Engineering Referral

DA No.	10.2018.483.1
Proposal:	Rural Tourist Accommodation: Eight (8) Cabins, Swimming Pool and Associated Works
Property description:	LOT: 4 DP: 621548 58 Montecollum Road WILSONS CREEK
Parcel No/s:	53590
Applicant:	Frank Stewart Architect
Owner:	Mr S B Yishay & Ms L B Levi
Zoning:	Zone No. RU2 Rural Landscape / PART DM Deferred Matter
Planning Officer:	Mr B J Grant
Referral Date:	26 June 2019

ASSESSMENT

Figure 3 Road past the Development Access

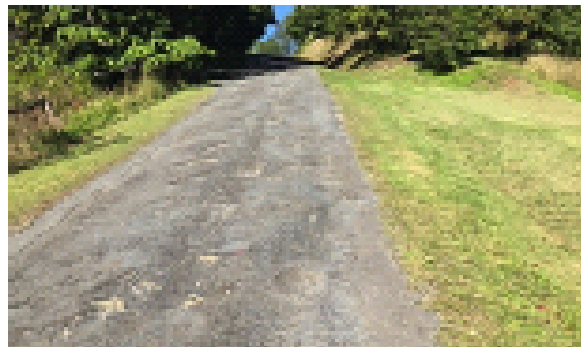
Montecollum Road	450m to 800m from Cedar Road east direction
Road cross section	5.0m pavement, 1.0m grassed shoulders/verge
Section length	450m
Speed	Assumed 50 km/h however due to the road formation vehicles can safely travel below 50 km/h
Running surface & condition	formed seal, reasonable condition with few pot holes
Side drainage	Table drain right side
Horizontal Alignment	Long straight sections
Vertical alignment	steep

There were no vehicles travelling the road during the inspection. The main safety concern is the ability and manoeuvrability to pass over the 5.0m wide road formation especially at bends. Vehicles tend to travel at slow speed due to the road formation, vertical & horizontal alignment and limited sight distance. The sealing of the full length of Montecollum Road will improve the driving comfort however it will not improve the road safety. Sealing is not warranted in this case. Safety of traffic at this section of Montecollum Road may be improved by regrading the road to provide a minimum road pavement and carriageway of 4.0m with the provision of passing bays at 200m.

1. The first 450m from Cedar Road;
2. From the end of the existing sealed section (approximately 800m from Cedar Road) and up to 10m past the proposed driveway servicing Cabin 1 to Cabin 6.

1. Generally in accordance with Council's standard drawing R13 for a rural crowned road with a formation of 4m carriageway with roadside drainage and table drains in accordance with Section D1.22 of NRLG D1 Geometric Road Design.
2. Provision shall be made to provide passing bay at 200m
